# Intel<sup>®</sup> Desktop Board DQ45CB Specification Update

July 2010

Order Number: E53961-007US

# Specification Update for the Intel<sup>®</sup> Desktop Board DQ45CB

**Figure 8. Detailed System Memory Address Map**

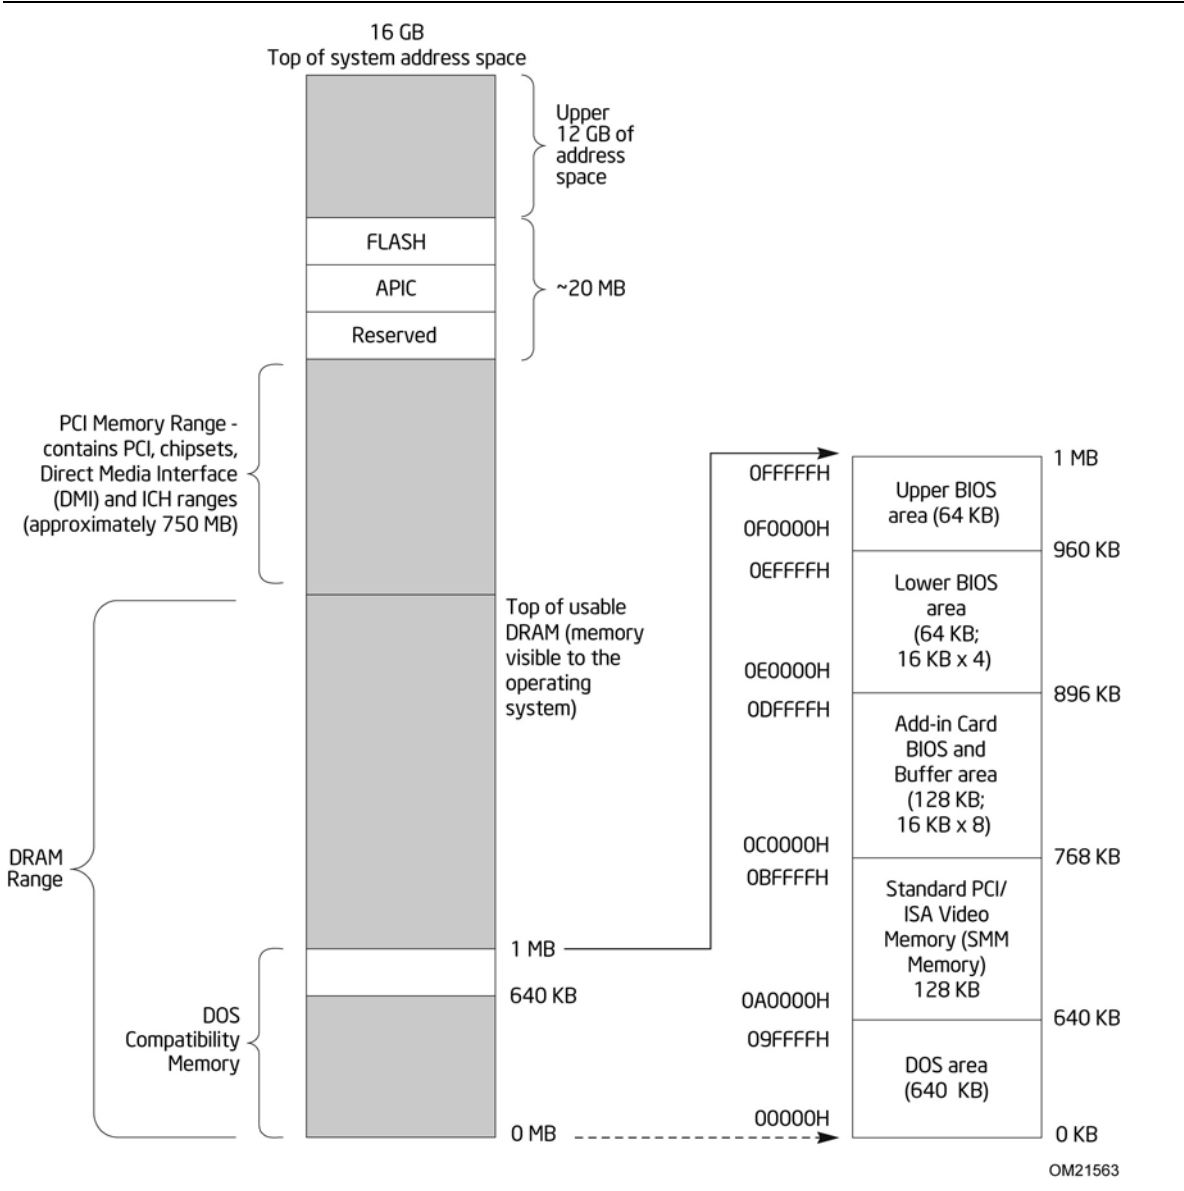
4. Support for up to 8 GB system memory has been changed to support for up to 16 GB system memory. Partial section of table 1 shown below.

The board utilizes 16 GB of addressable system memory. Typically the address space that is allocated for PCI Conventional bus add-in cards, PCI Express configuration space, BIOS (SPI Flash), and chipset overhead resides above the top of DRAM (total system memory). On a system that has 16 GB of system memory installed, it is not possible to use all of the installed memory due to system address space being allocated for other system critical functions. These functions include the following:

The amount of installed memory that can be used will vary based on add-in cards, BIOS settings, and operating system installed. Figure 8 shows a schematic of the system memory map. All installed system memory can be used when there is no overlap of system addresses.
